Addendum 10

Re: White Mountain Apache Tribe – Fort Apache Boys Dormitory Remodel
LSW Project No. 2020-175.000

Subject: Delta 2 (Addendum 10) MPE Revisions

DRAWN	MLL
CHECKED	ELB
DATE	08.16.2023
SCALE	3/16" = 1'-0"
JOB NO.	2101
SHEET	E4.01

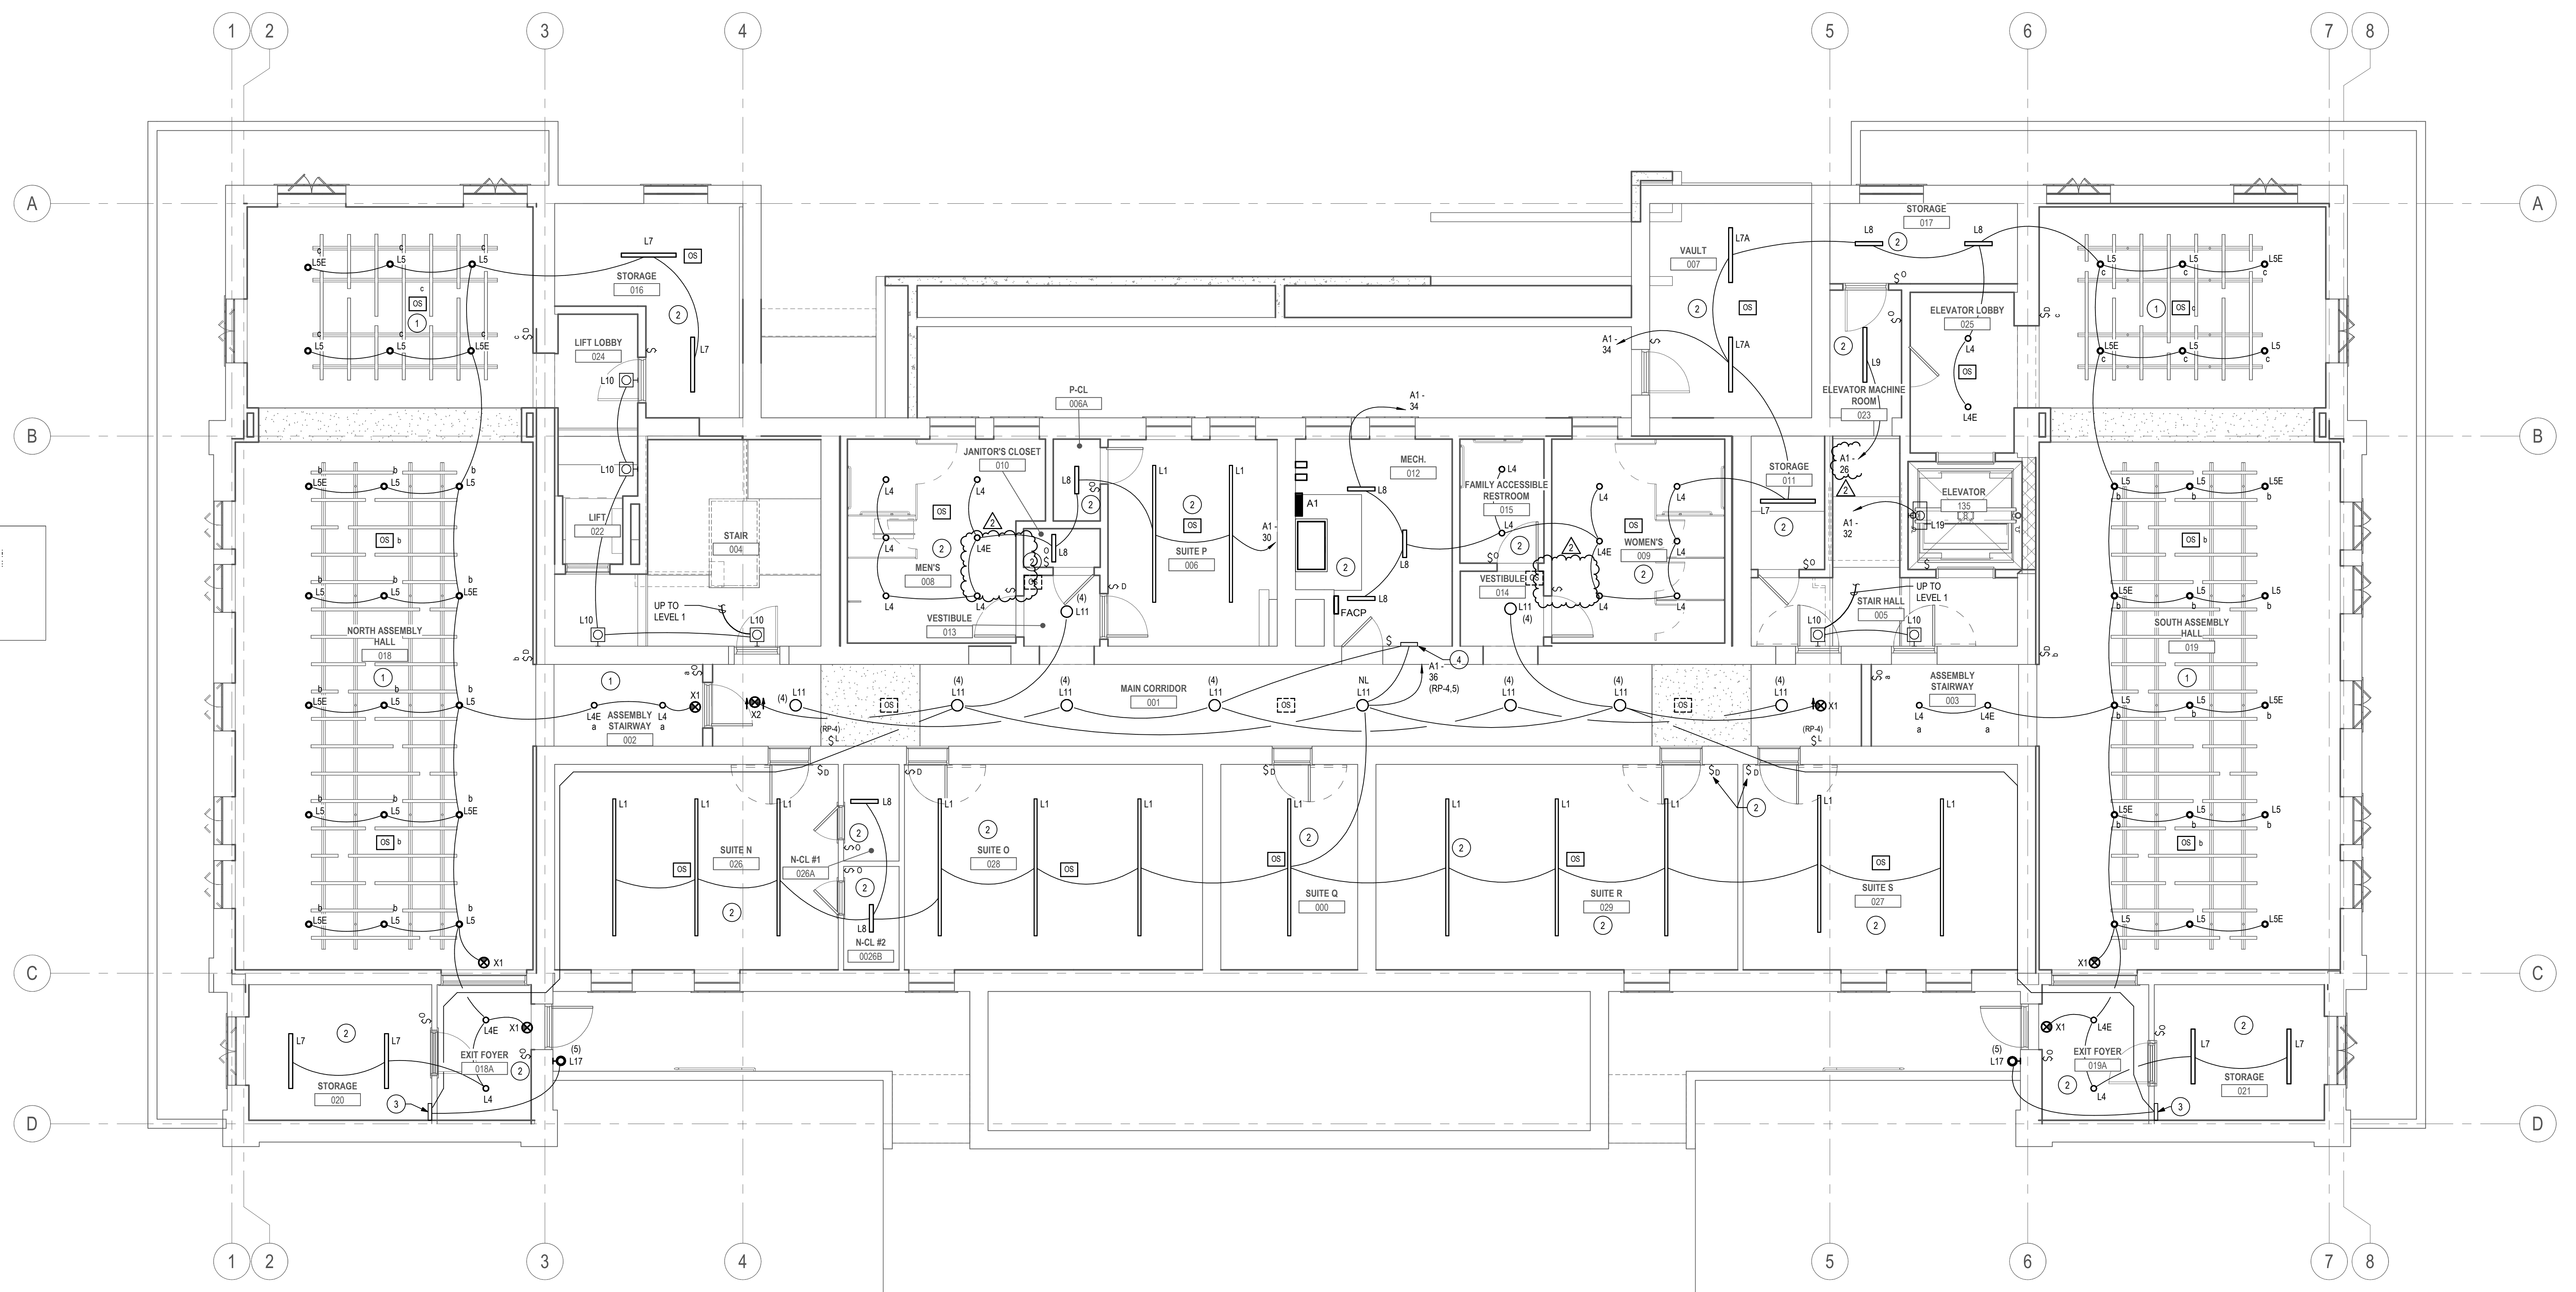
7. Updated circuit for elevator machine room lighting to better balance loads after pump changes noted above. There are no changes to circuit/breaker sizes.
8. Removed keyed notes at occupancy sensors in restroom vestibules per response to bidder question.

DRAWN MLL
CHECKED ELB
DATE 08.16.2023
SCALE 3/16" = 1'-0"
JOB NO. 2101
SHEET E4.02

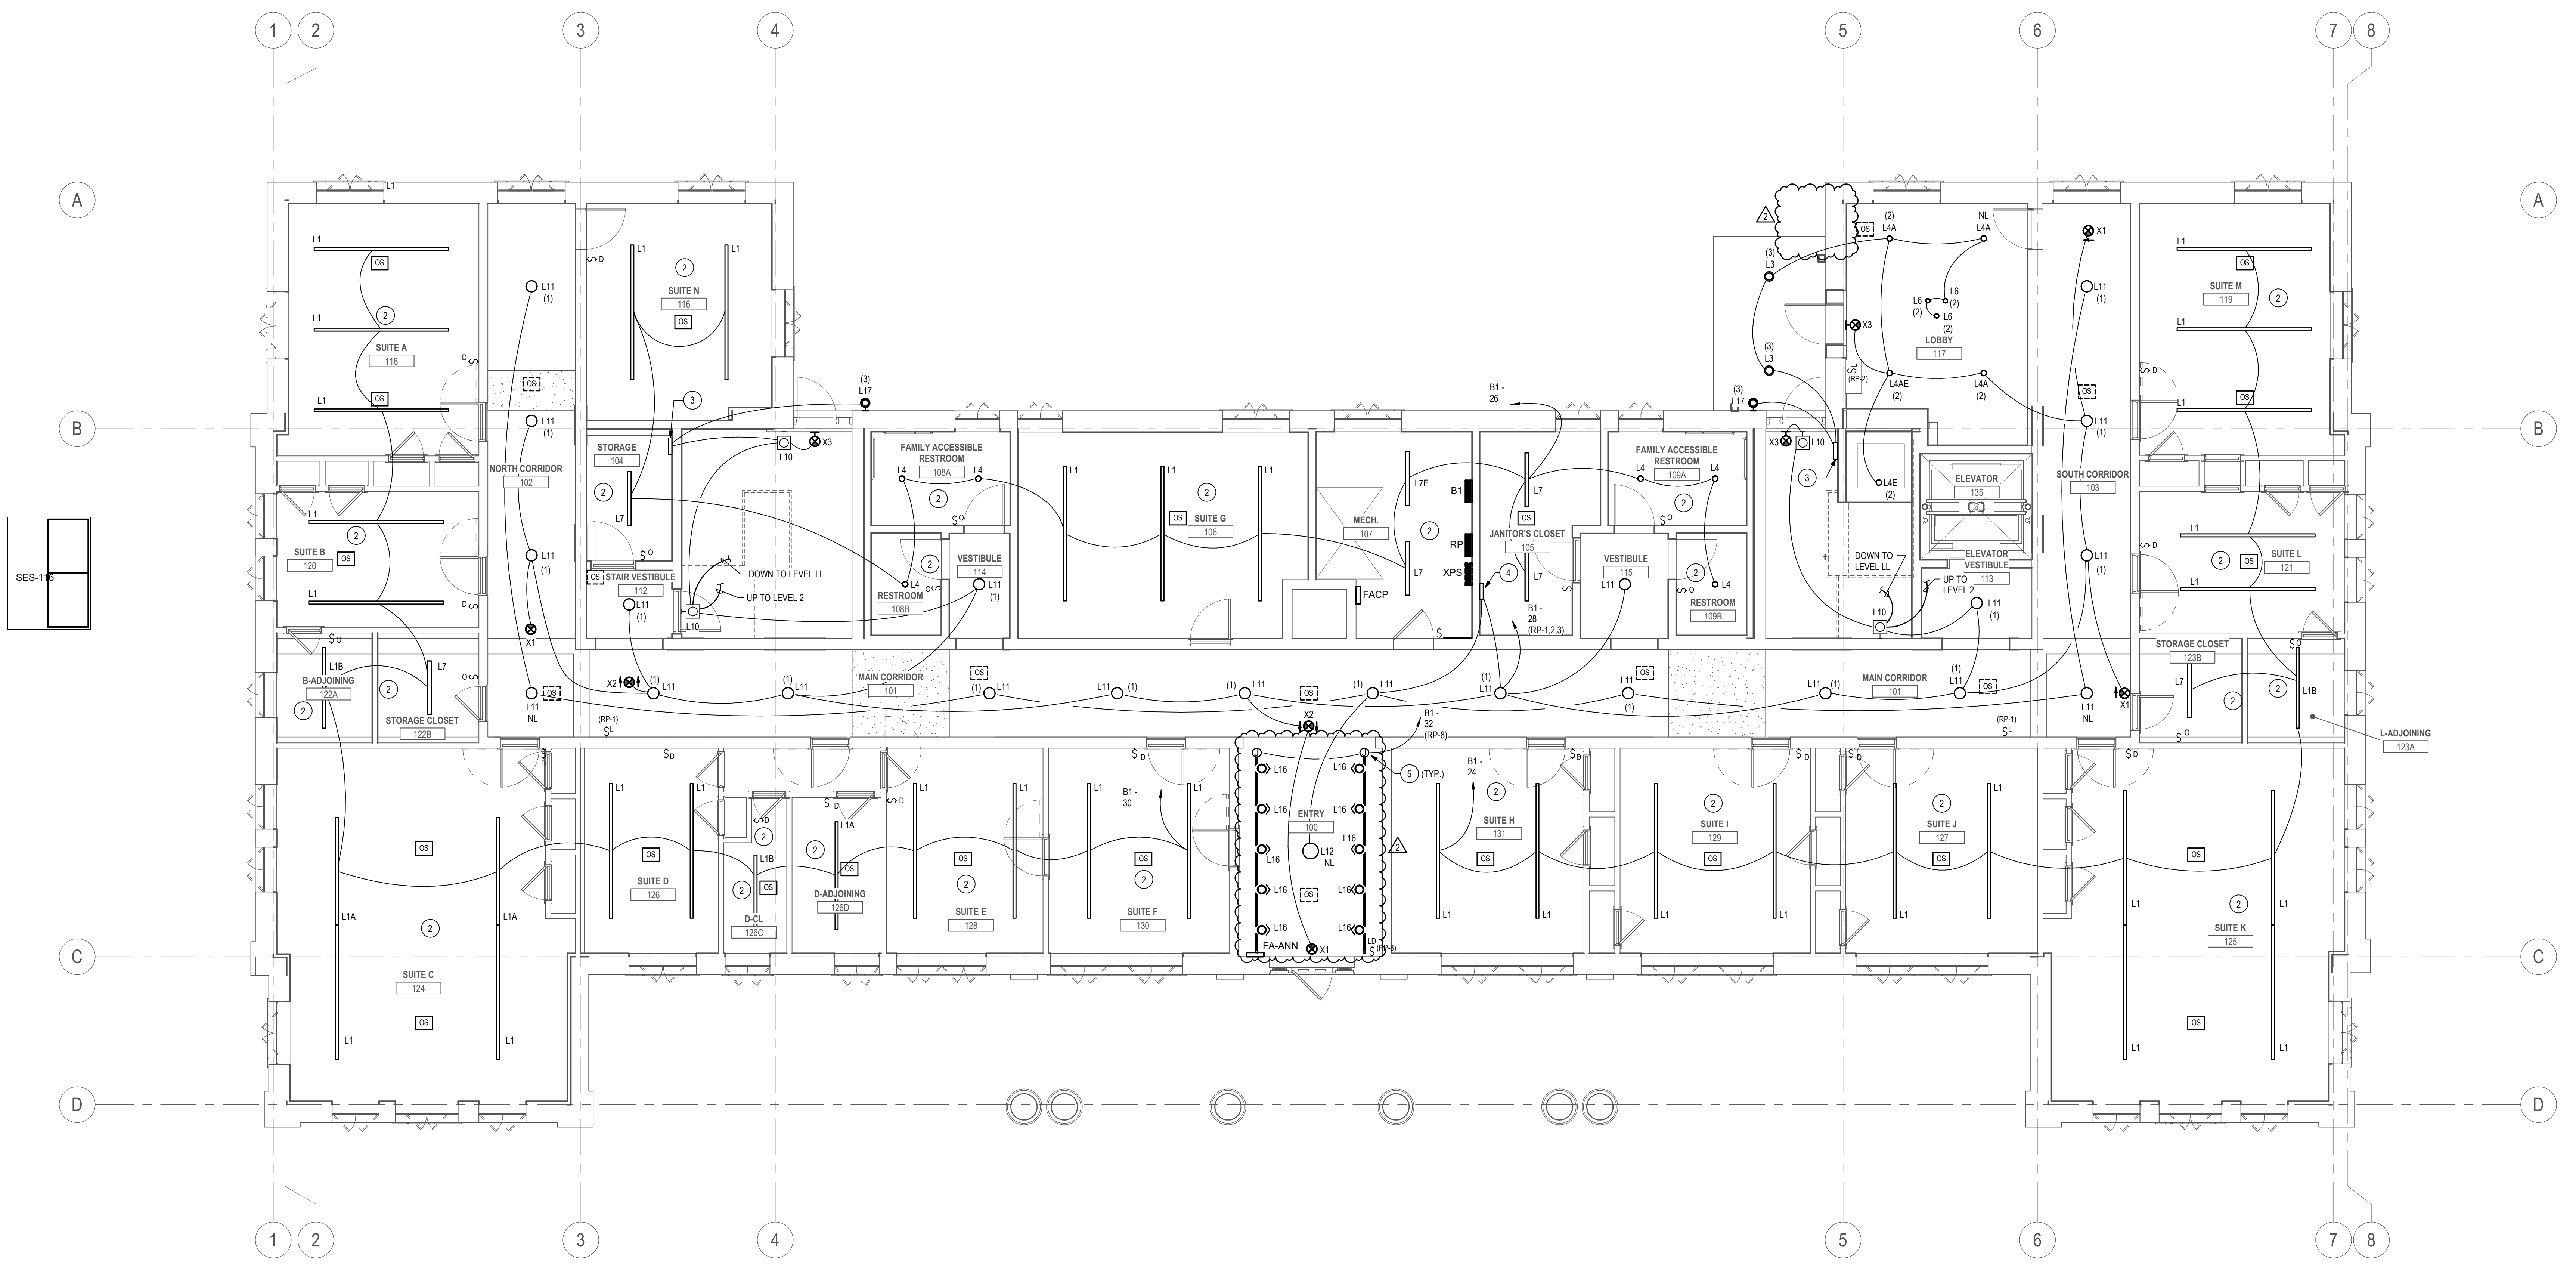
9. Added track lighting fixture type in Entry per response to bidder question.
10. Removed keyed note at occupancy sensor in Lobby per response to bidder question.

DRAWN	MLL
CHECKED	ELB
DATE	08.16.2023
SCALE	3/16" = 1'-0"
JOB NO.	2101
SHEET	E4.03

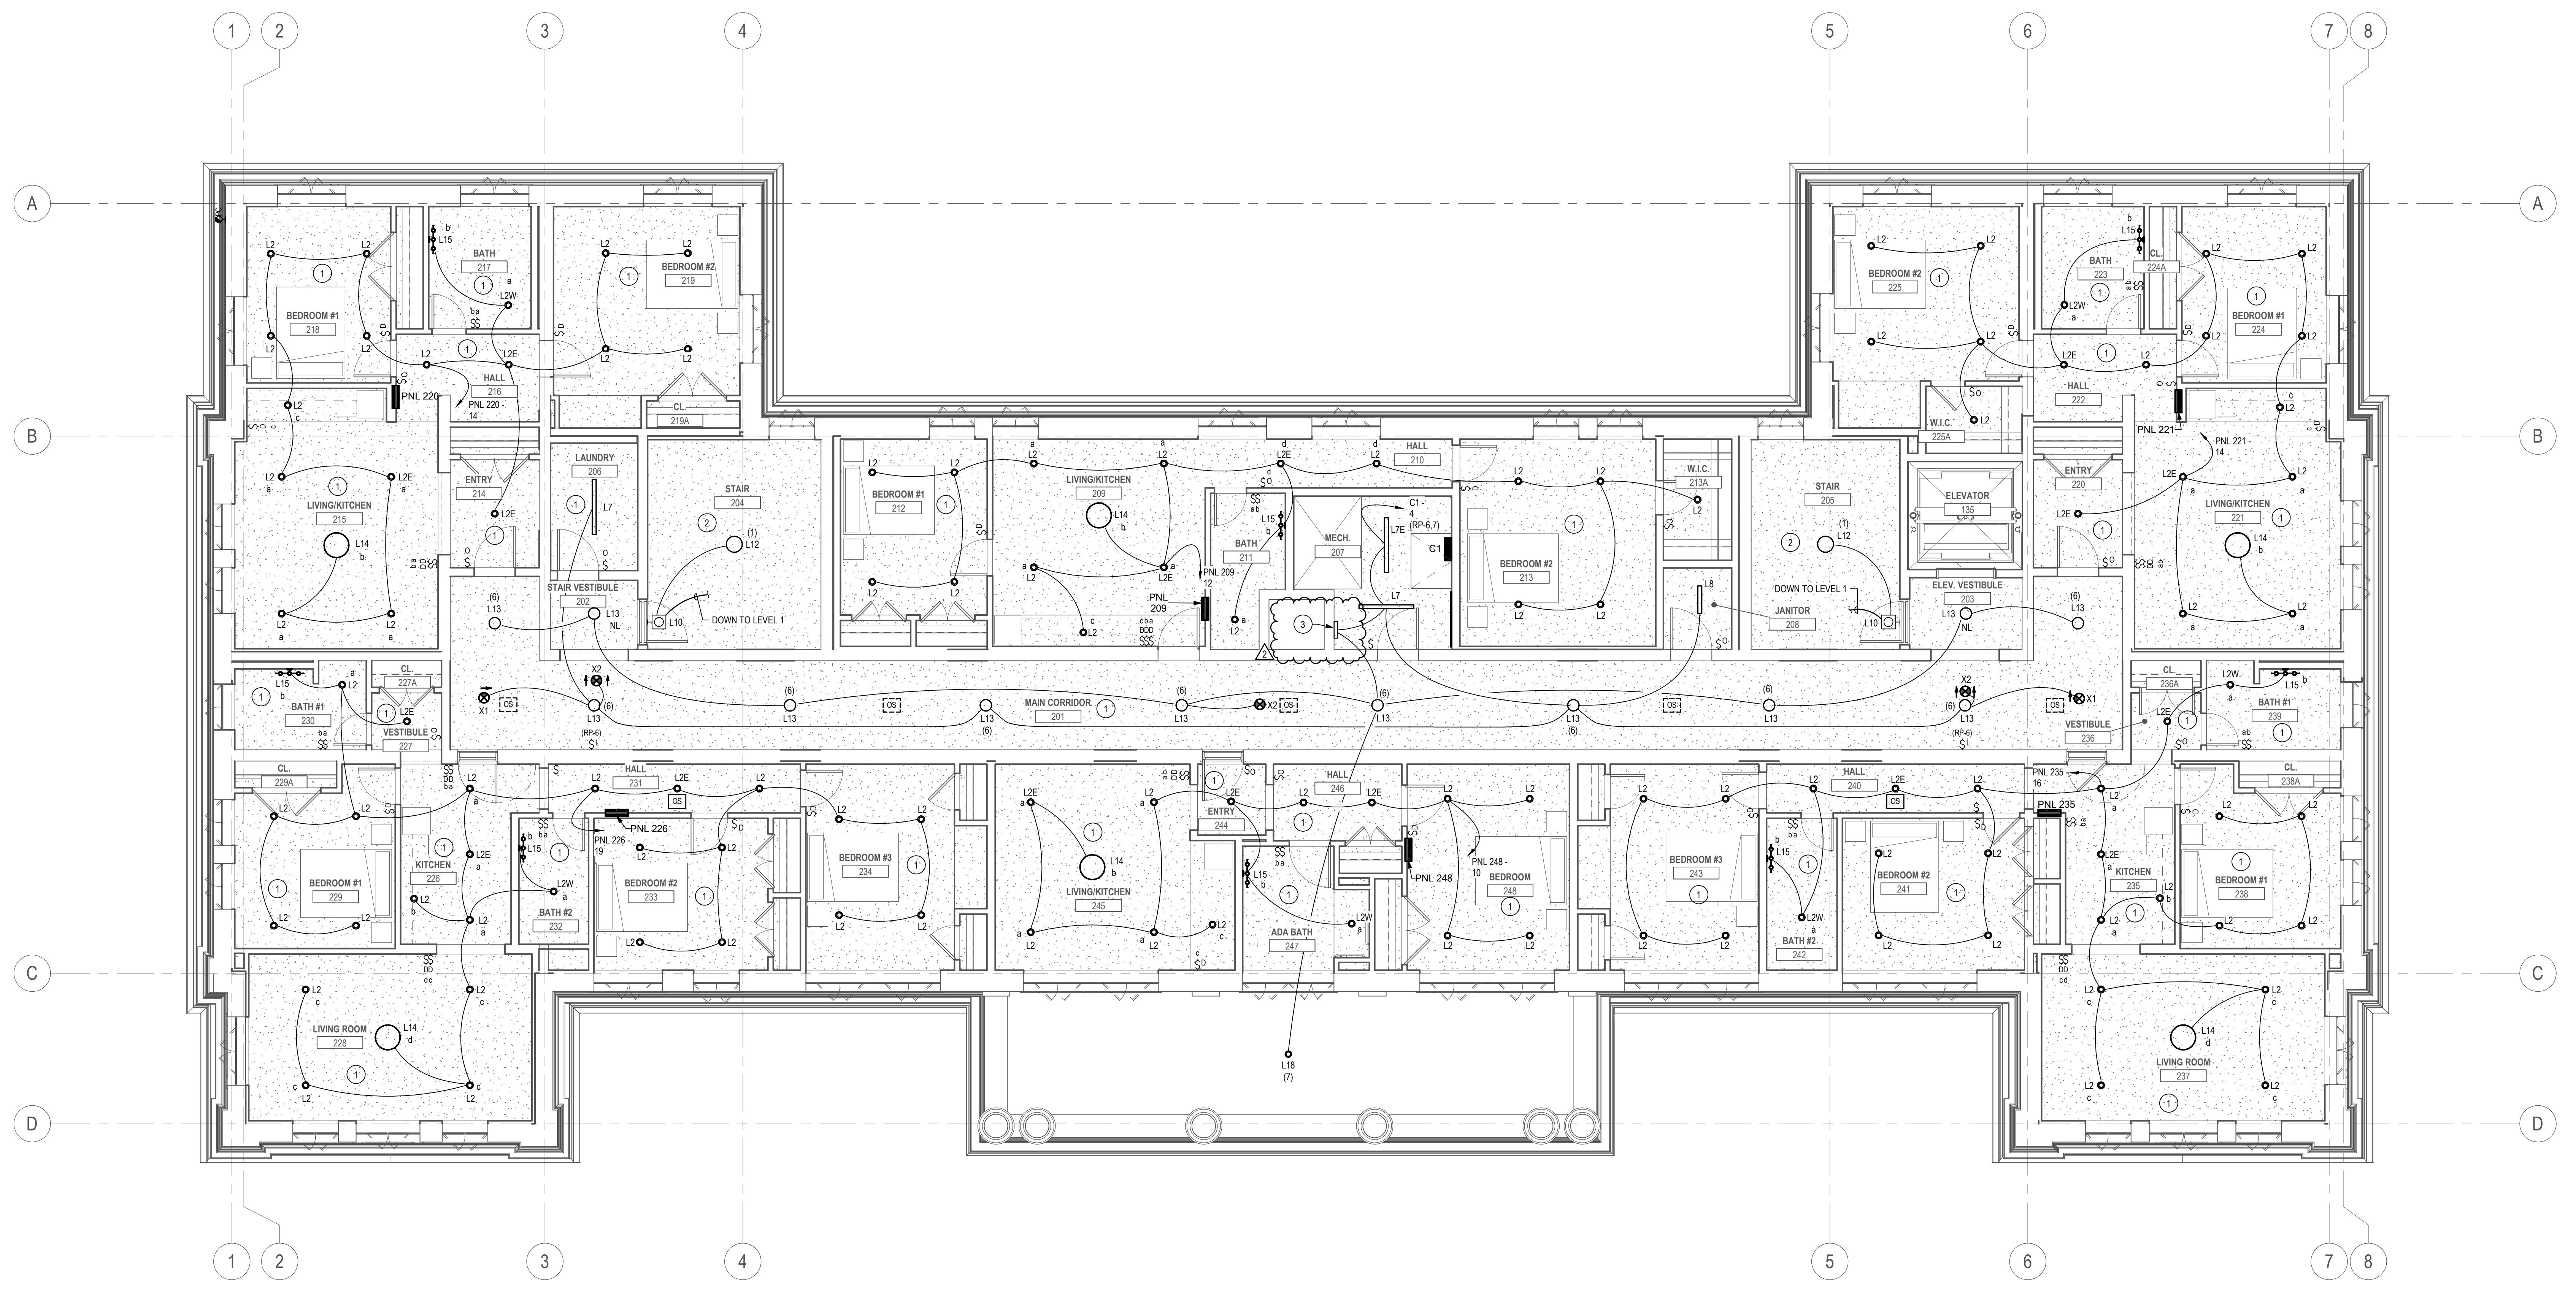
11. Added keyed note 3 at box in Mechanical room per response to bidder question.
